WINDERMERE PRELIMINARY PLAN

$E^{1/2}$ OF SECTION 29, T13S, R65W OF THE 6TH P.M. EL PASO COUNTY, COLORADO

WINDERMERE METRO DIST. COUNTY FILE NO.: SP-19-003 | SHEET: 1 OF 10

SP19003-V2-PrelimPlan redlines.pdf Markup Summary 8-20-2020

COUNTY FILE NO.: SP-19-003 SHEET: 2 OF 10

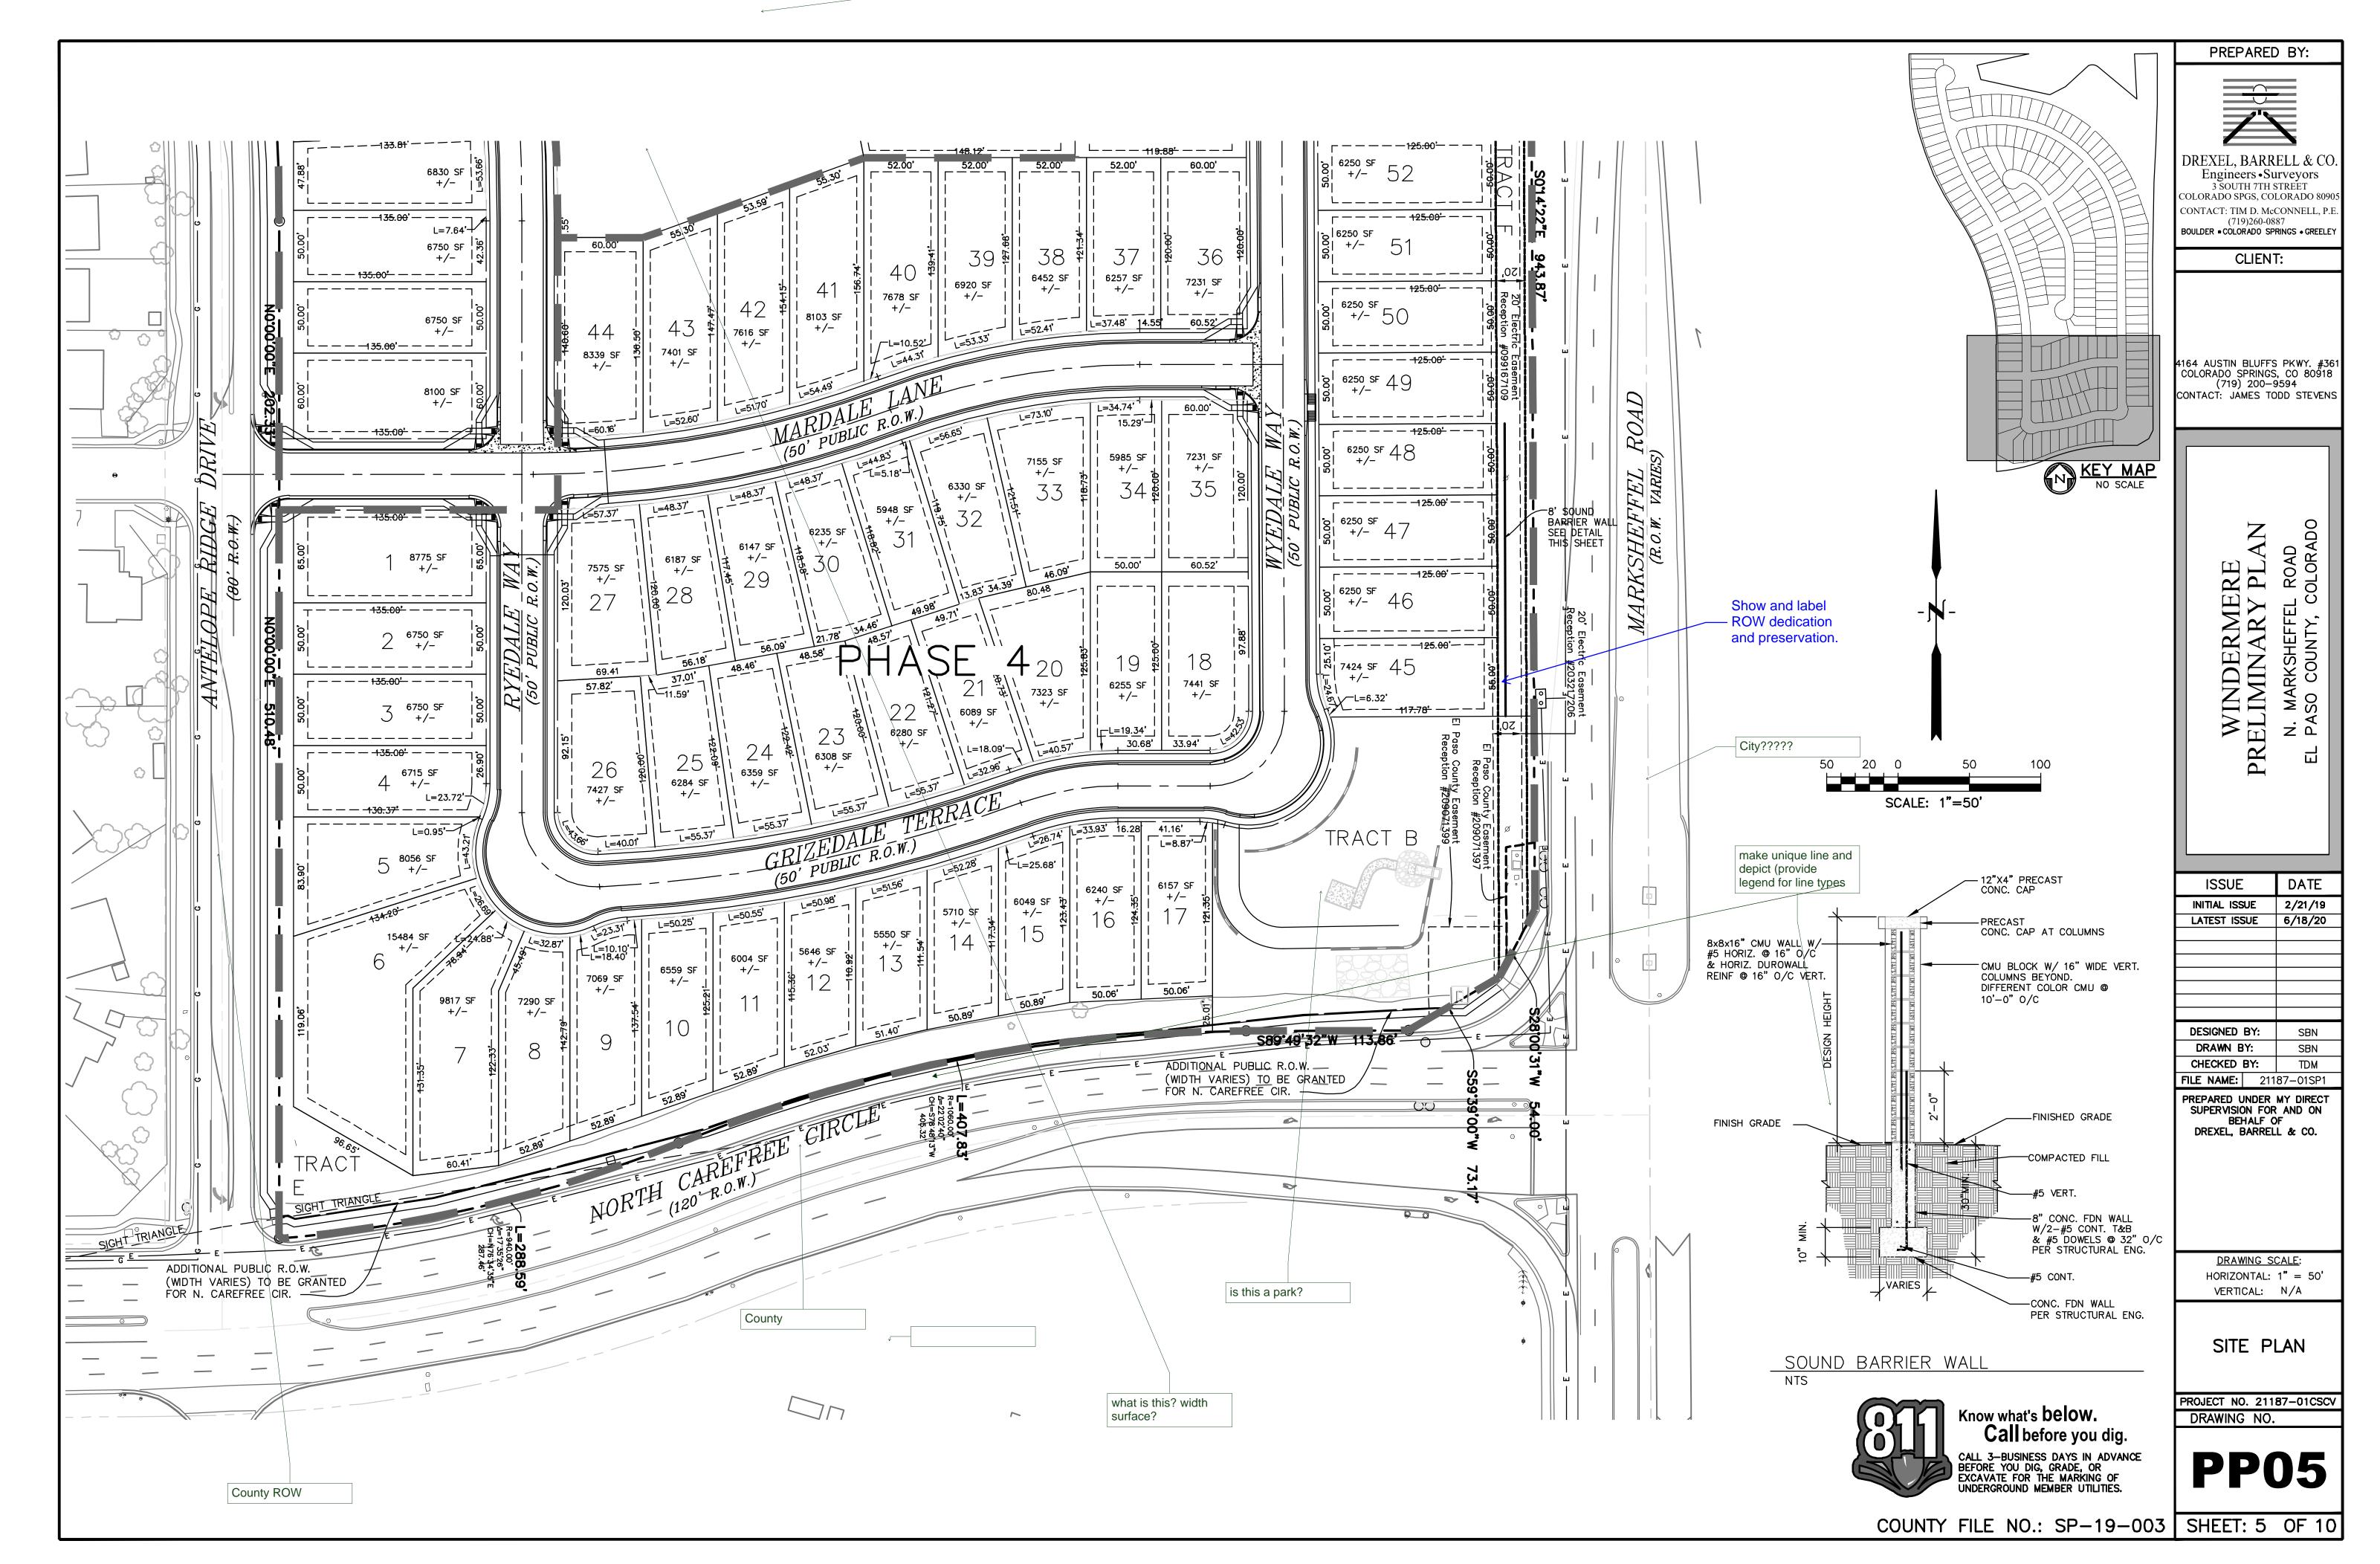
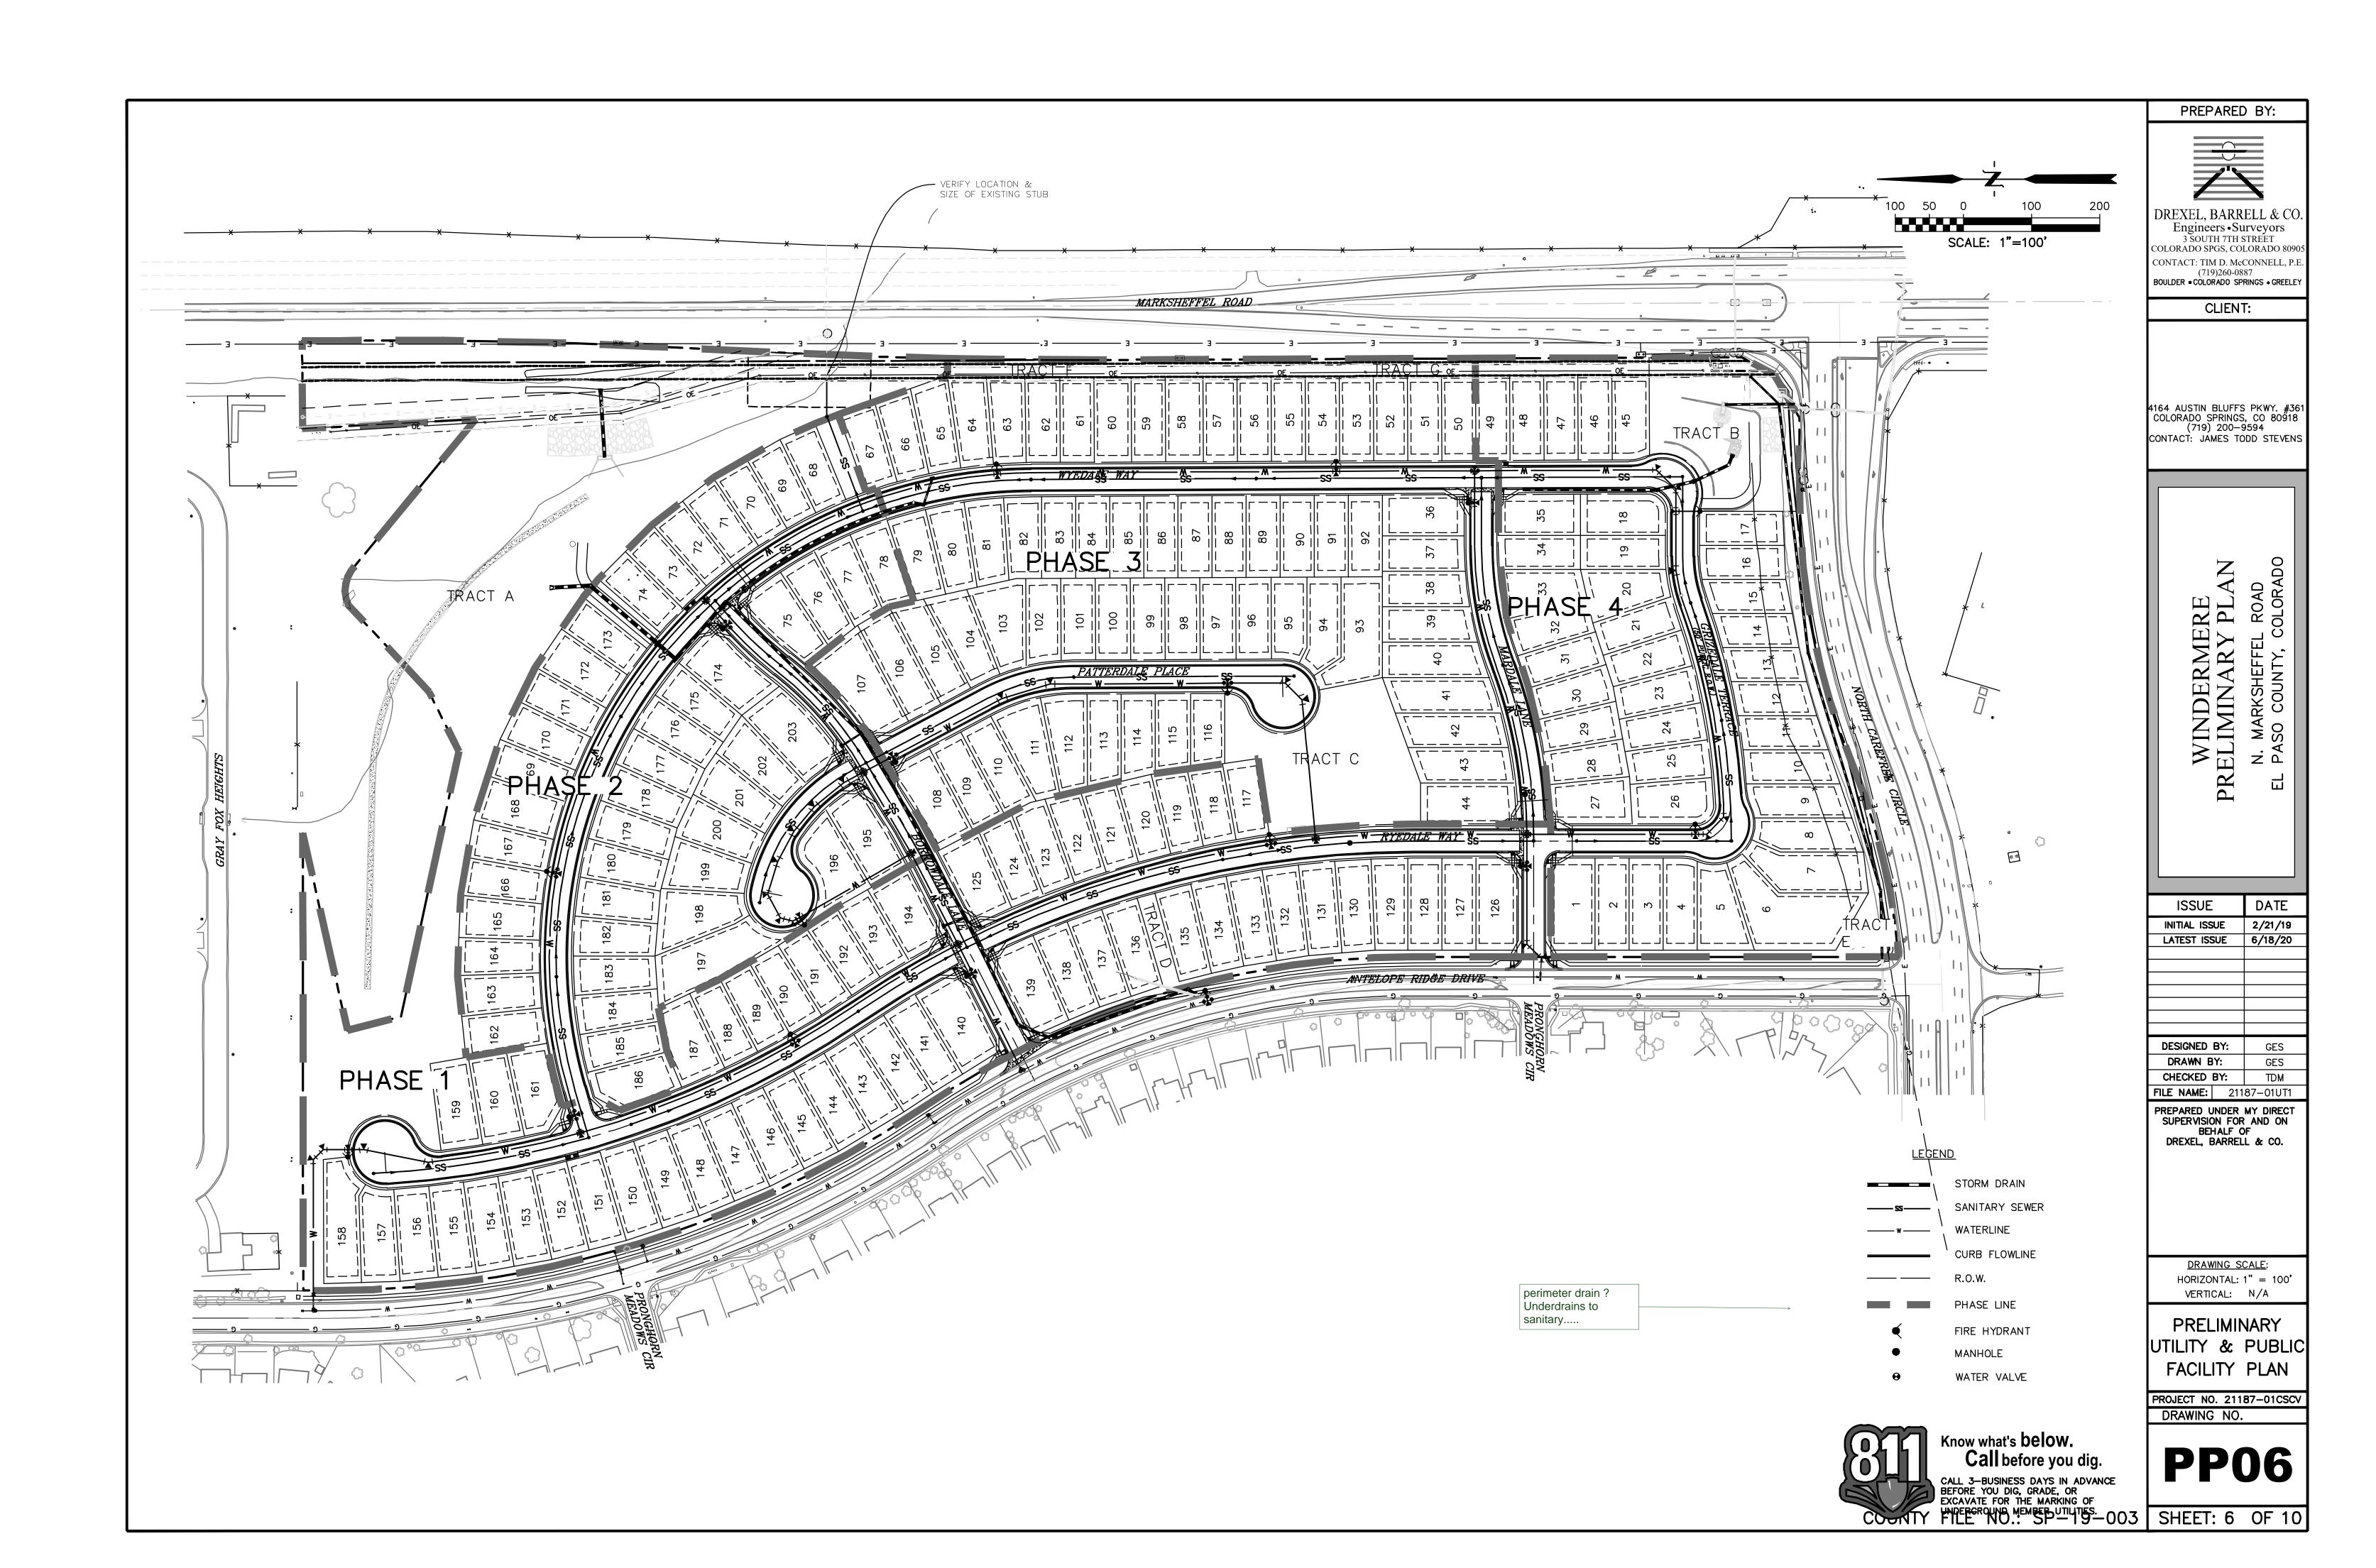
Status: Color: Layer: Space: Show the adjacent property/ROW lines

Status: Color: Layer: Space: wall can't be in the ROW

Status: Color: Layer: Space: Dimension the ROW dedication and total width at applicable locations. This doesn't match MTCP.

Subject: Callout title every page Page Label: [2] 2 21187-01SP1 - SP1 Author: dsdparsons Date: 8/20/2020 5:03:46 PM Status: Color: Layer: Space: Subject: Callout phase plan Page Label: [2] 2 21187-01SP1 - SP1 Author: dsdparsons Date: 8/20/2020 5:04:05 PM Status: Color: Layer: Space: Subject: Callout preliminary plan Page Label: [3] 3 21187-01SP1 - SP2 Author: dsdparsons Date: 8/20/2020 5:04:19 PM Status: Color: Layer: Space: Subject: Callout phase plan Page Label: [1] 1 21187-01CV1 - DP01 Author: dsdparsons Date: 8/20/2020 5:04:42 PM Status: Color: Layer: Space: Subject: Callout preliinary plan Page Label: [1] 1 21187-01CV1 - DP01 Author: dsdparsons Date: 8/20/2020 5:04:53 PM

ROW Preservation?

ROW dedication?
